Agenda Item #1

Application 2025-33-CA

Replace six porch columns with fiberglass columns.
Rebuild three double bases.

2. Location of removed columns, looking E

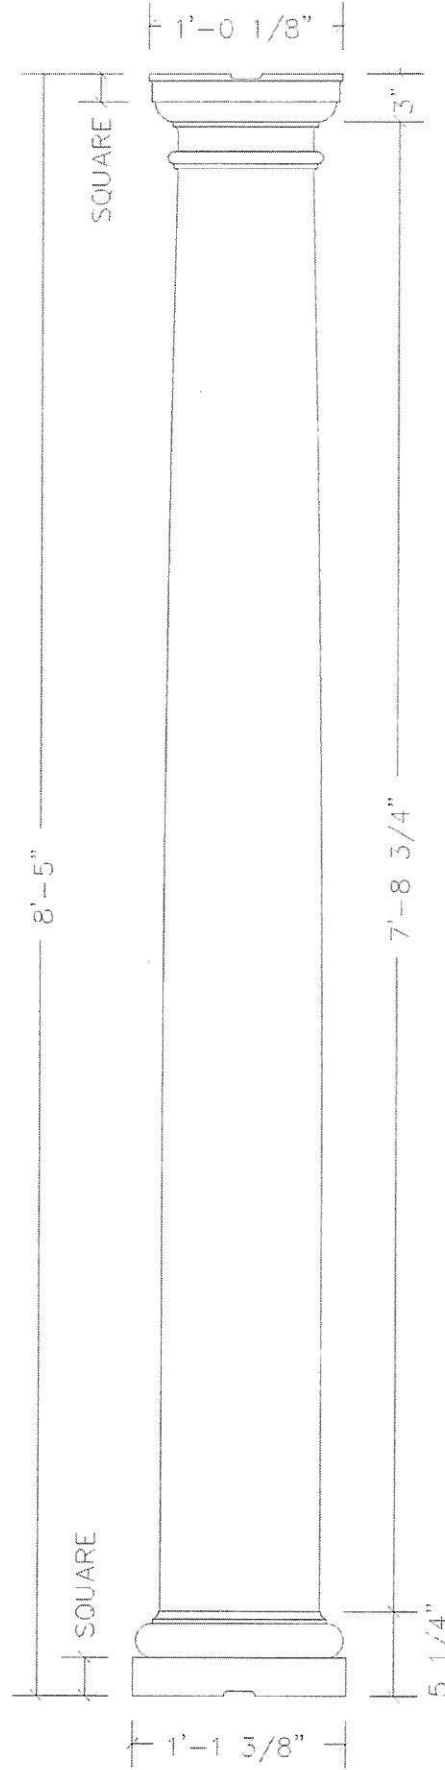
The applicant received a COA in February 2025 to replace the larger wood base on which the center paired columns rest. When the columns were removed to carry out the base replacement, significant deterioration was discovered near the base of the columns. In April 2025, the applicant applied to replace the two (2) deteriorated wood columns with fiberglass columns. The staff report and meeting discussion deemed the columns beyond repair. A schematic of the proposed replacement column was submitted which closely matched the profile of the original columns, with a noted slight departure in molding detail at the capital and base. With agreement from the applicant, the Board gave conditional approval for the two replacement fiberglass columns, contingent on Staff approval of a resubmitted replacement column design that matched the original columns (and therefore the remaining four original wood columns) exactly. Over the following months, the applicant attempted to acquire an exact match, staying in touch with Staff. They ultimately discovered that fiberglass columns could not be reproduced to a 100% match to the original design. Additionally, ordering wood columns to be milled identically to the original are extremely cost prohibitive to the owner. The subject application is an alternative solution: replacing all six (6) columns with fiberglass replacements in the previous submitted design which would result in six matching replacement columns that express a very similar profile to the original but are not an exact match. The applicant has determined that this option is much more financially feasible than ordering two duplicate wood columns. Although not identical, the submitted design is an appropriate profile which is consistent with the classical expression of the structure and would minimally impact the stylistic details of the front porch, given the proposal of wholesale replacement.
